URBAN DESIGN COMMISSION APPLICATION

SHEET LIST - ARCHITECTURAL	
SHEET NUMBER	SHEET NAME
PR0.0	COVERSHEET FOR PROPOSED CHANGES
PR1.1	BUILDING 1 & 2 PROPOSED CHANGES - FLOOR PLAN
PR1.2	BUILDING 1 & 2 PROPOSED CHANGES - ELEVATIONS
PR1.3	BUILDING 1 & 2 PROPOSED CHANGES - ELEVATIONS
PR1.4	BUILDING 1 & 2 PROPOSED CHANGES - ELEVATIONS
PR1.5	BUILDING 1 & 2 PROPOSED CHANGES - ELEVATIONS
PR1.6	BUILDING 1 & 2 PROPOSED CHANGES - ELEVATIONS
PR2.1	BUILDING 3 PROPOSED CHANGES - FLOOR PLAN
PR2.2	BUILDING 3 PROPOSED CHANGES - ELEVATIONS
PR2.3	BUILDING 3 PROPOSED CHANGES - ELEVATIONS
PR2.4	BUILDING 3 PROPOSED CHANGES - ELEVATIONS
PR3.1	BUILDING 4 PROPOSED CHANGES - FLOOR PLAN
PR3.2	BUILDING 4 PROPOSED CHANGES - ELEVATIONS
PR3.3	BUILDING 4 PROPOSED CHANGES - ELEVATIONS
PR3.4	BUILDING 4 PROPOSED CHANGES - ELEVATIONS
PR3.5	BUILDING 4 PROPOSED CHANGES - ELEVATIONS

MULTI-FAMILY HOUSING
THE MEADOWLANDS
MADISON, WI
KCG HOUSING DEVELOPMENT

THE MEADOWLANDS - PROPOSED SITE PLAN CHANGES

1
PR3.1
1/16" = 1'-0"
FIRST FLOOR - PROPOSED CHANGES

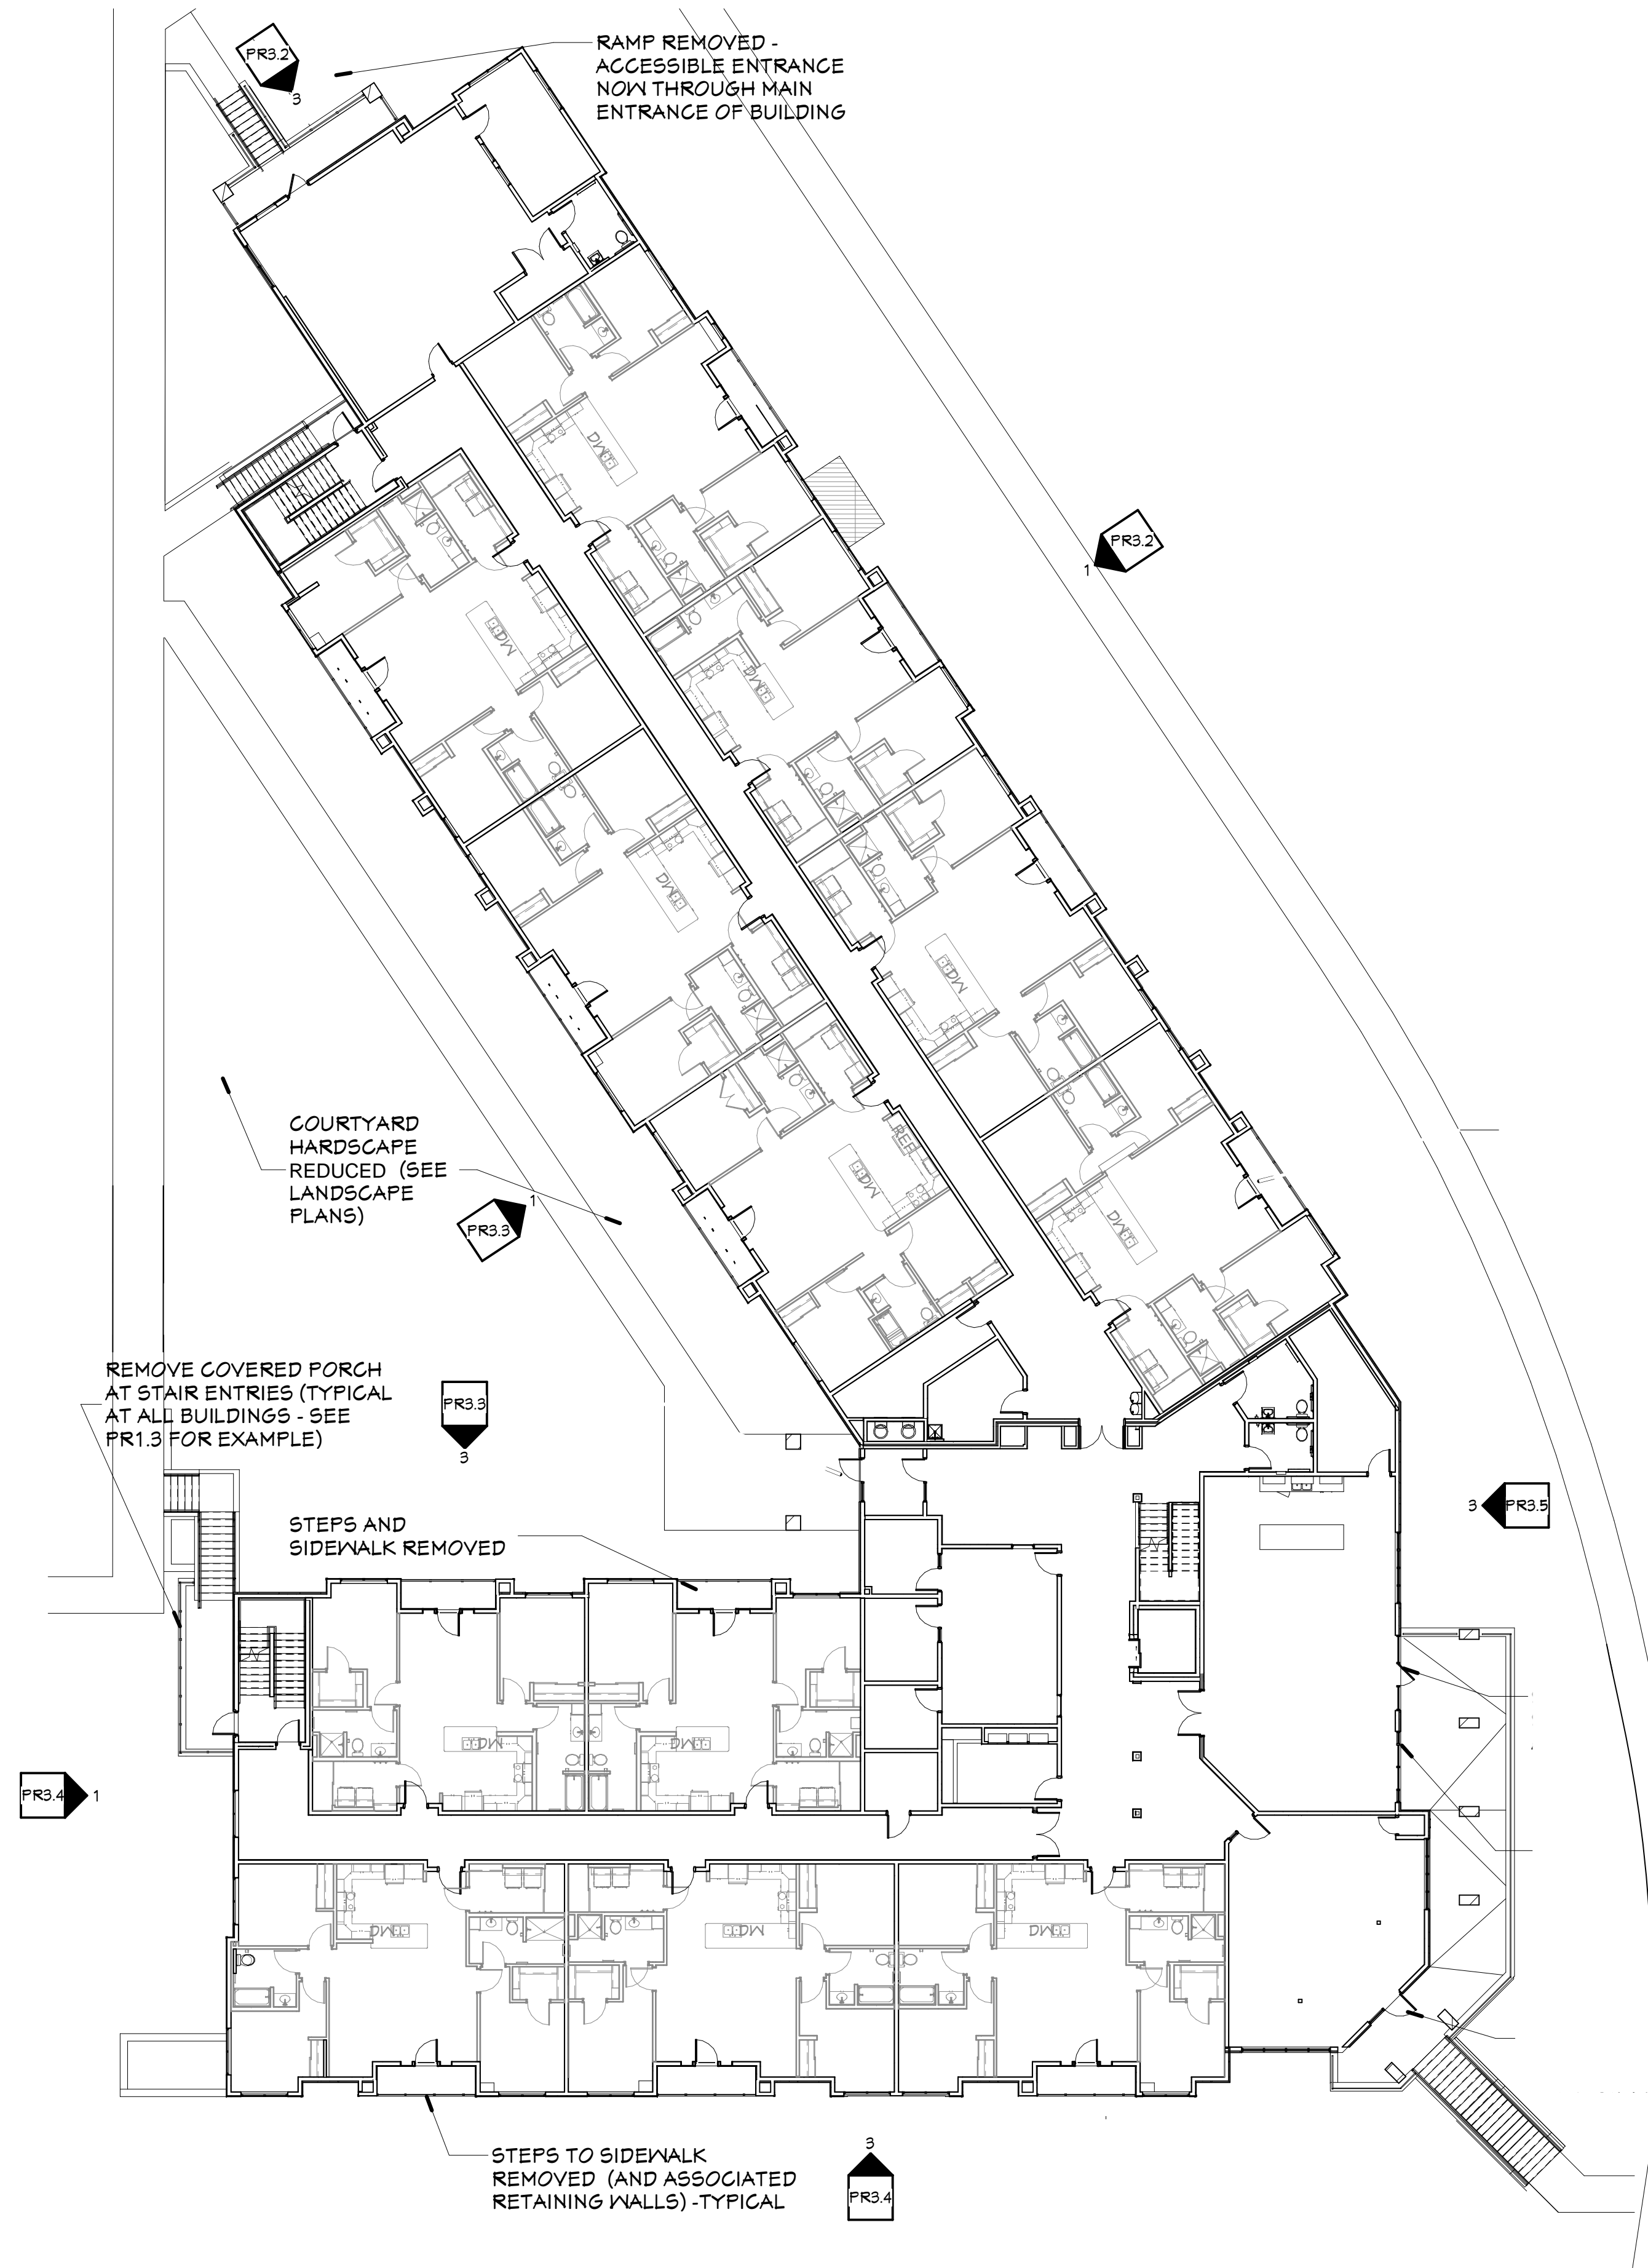
- Ramp serving Human Services Office – provide alternative access
 - Building 4, north end
 - Reference Pages: PR 3.1, 3.2
 - Approved Design
 - Accessible access to the Human Services Office was provided on the approved plans via an intricate ramp system immediately in front of the office space.
 - Proposed Revision
 - The accessible route into the Office will be provided from the interior corridor of Building 4, therefore eliminating the need for the ramp. Accessible route signage will be provided, as required.

1. REMOVE STEPS TO FIRST FLOOR PRIVATE PATIOS AND ASSOCIATED SIDE WALKS & RETAINING WALLS
2. RAMP ON NORTH SIDE OF BUILDING REMOVED
3. COURTYARD HARDSCAPE RECONFIGURED (SEE LANDSCAPE DRAWING)
4. DECORATIVE SCONCES REMOVED (LIGHTING PLACED IN SOFFIT ABOVE WHERE APPLICABLE)
5. REMOVE ROOF TO PORCH AT STAIR ENTRIES (TYPICAL OF ALL END BUILDINGS ENTRIES ONLY)
6. REDUCE PORCH SIZE AT STAIR ENTRIES.

3 NORTH ELEVATION - BLDG 4 - PROPOSED DESIGN

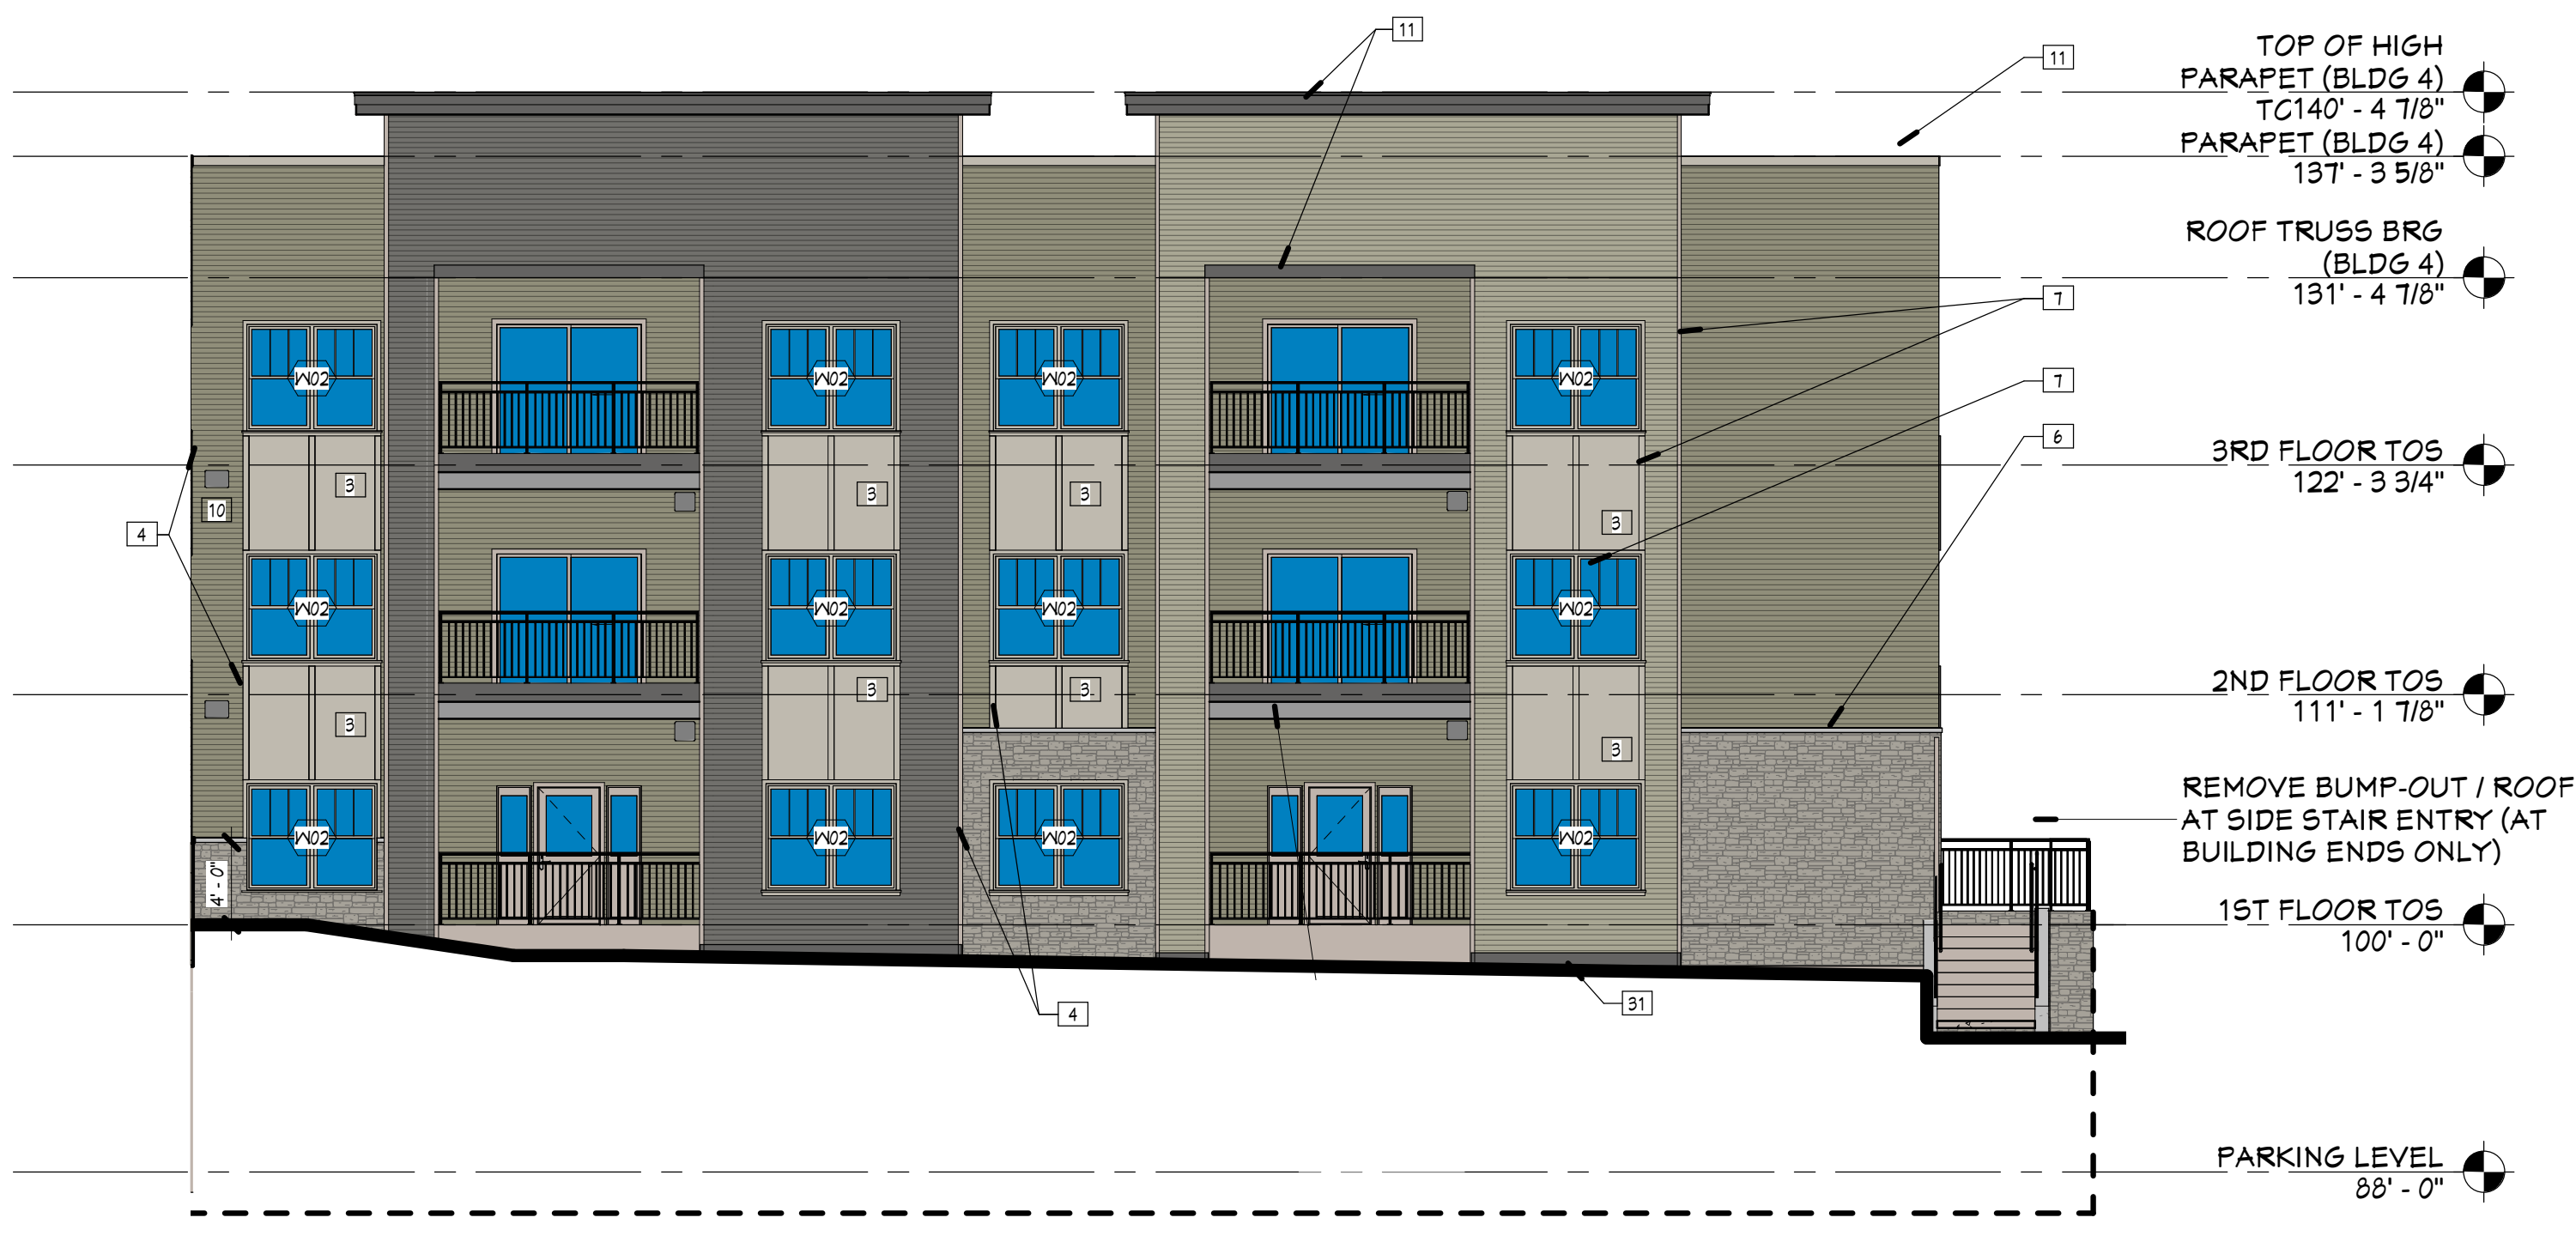
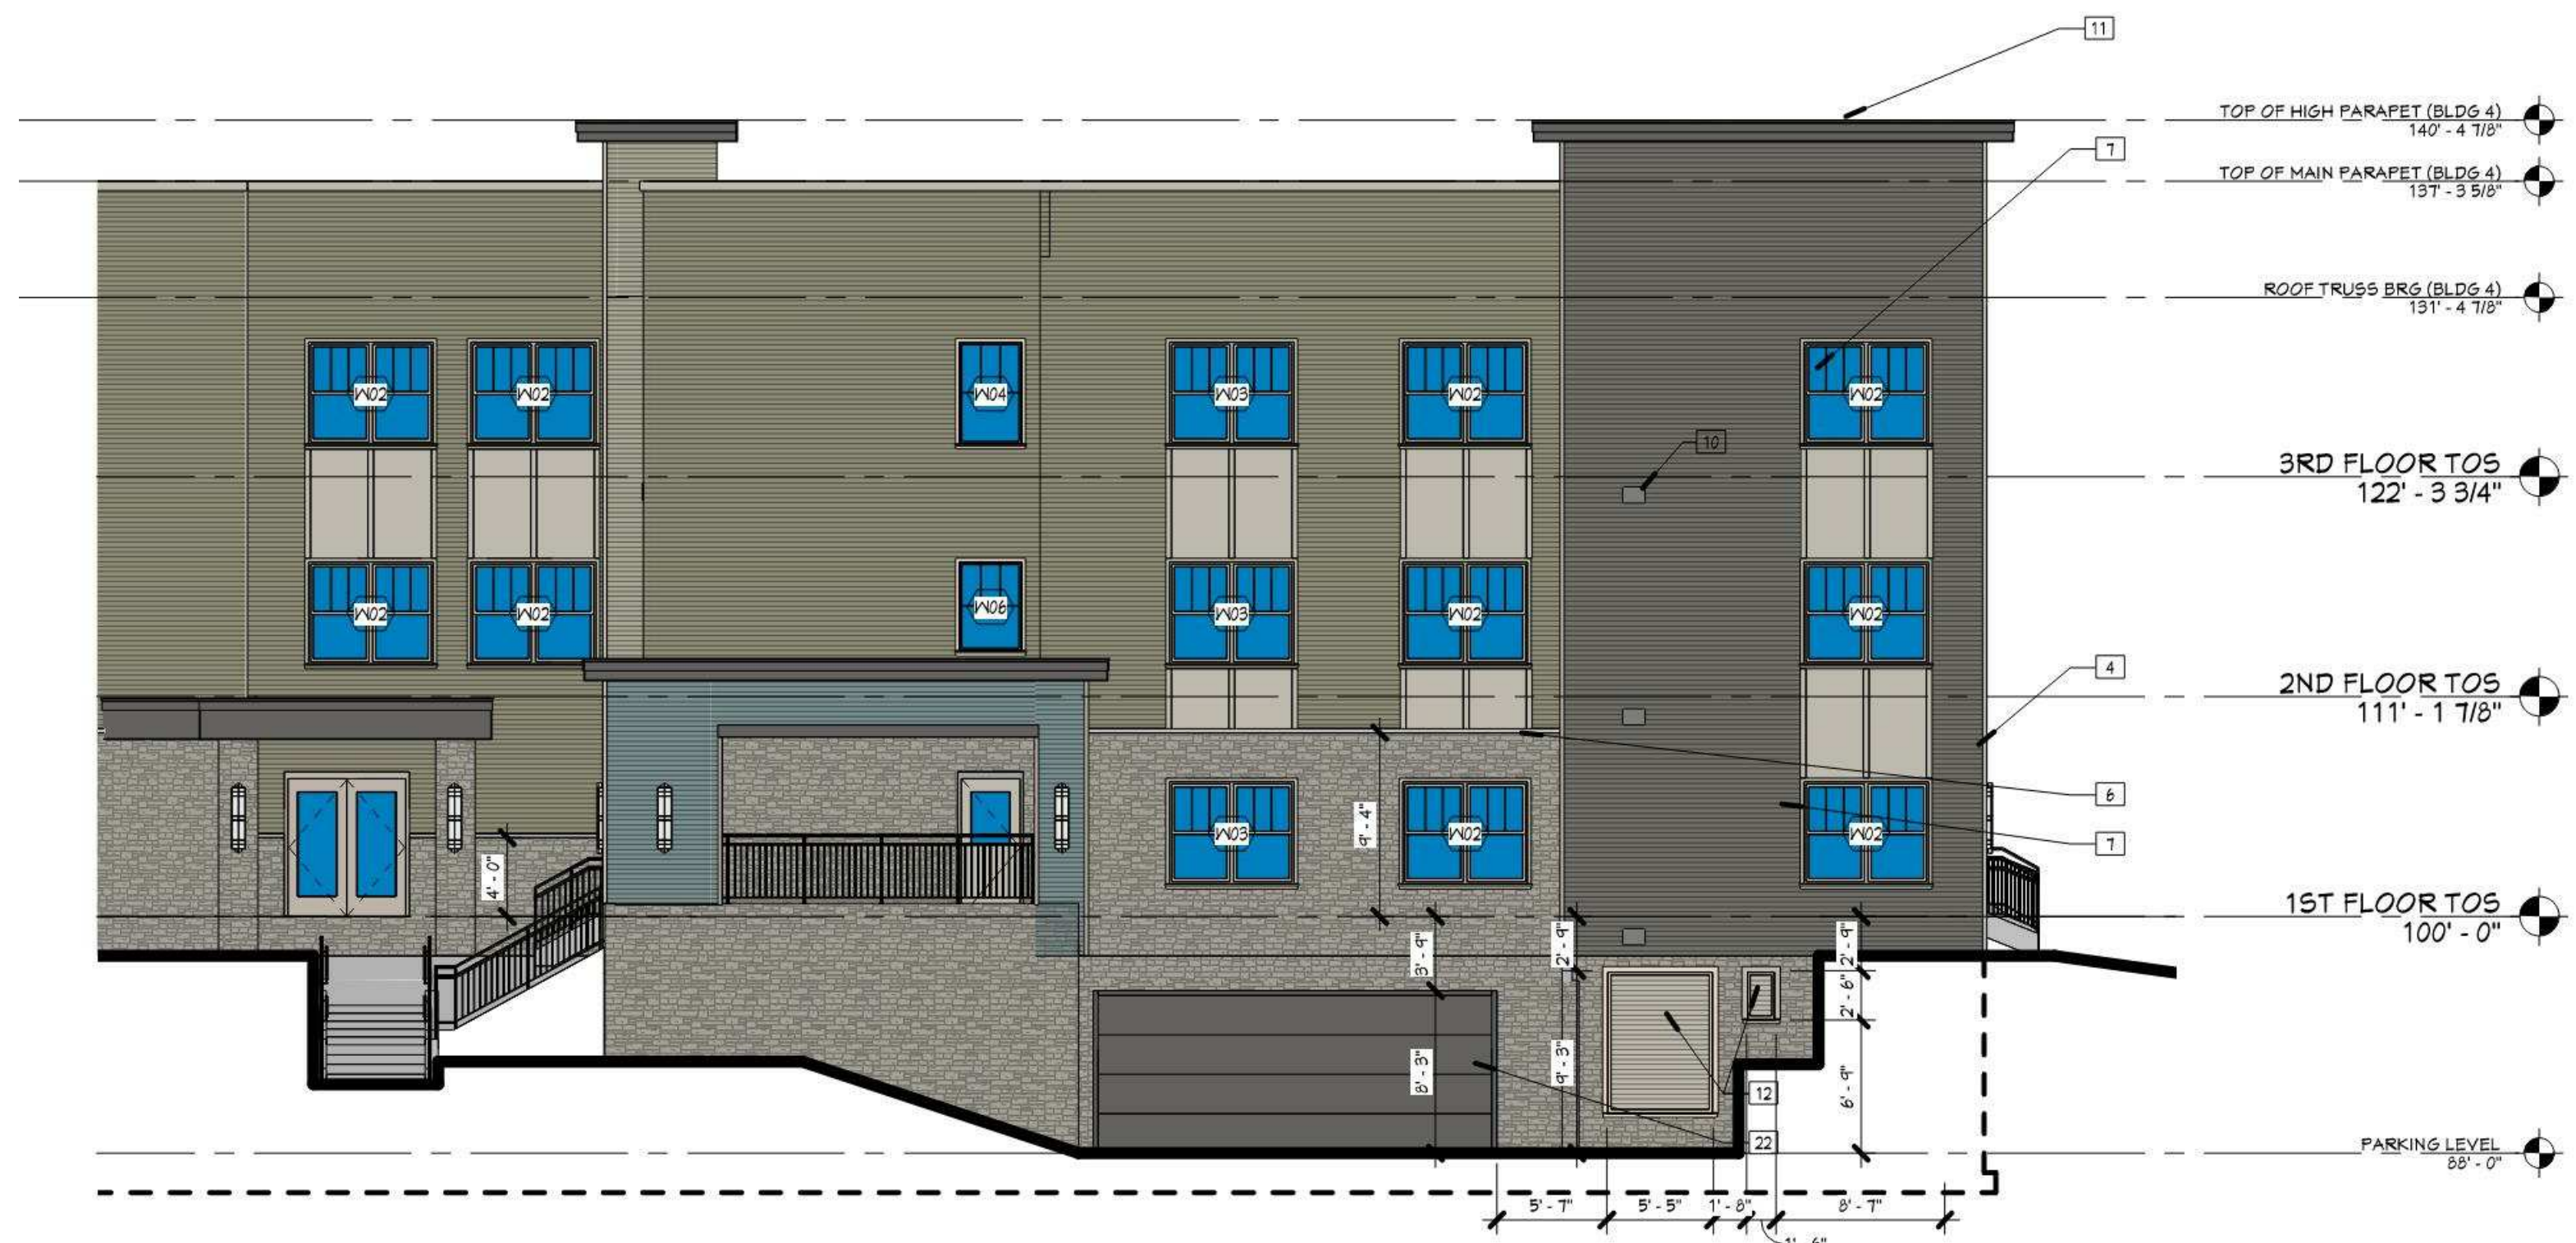
- Human Service Office Storefront Assembly – revise storefront appearance
 - Building 4, north end
 - Reference Pages: PR 3.2
 - Approved Design
 - Continuous storefront appearance; entry door + two windows on each side
 - Proposed Revision
 - Provide single door with full height window and transom + adjacent window

1. REMOVE STEPS TO FIRST FLOOR PRIVATE PATIOS AND ASSOCIATED SIDE WALKS.
2. DECORATIVE SCONCES REMOVED (LIGHTING PLACED IN SOFFIT ABOVE WHERE APPLICABLE)
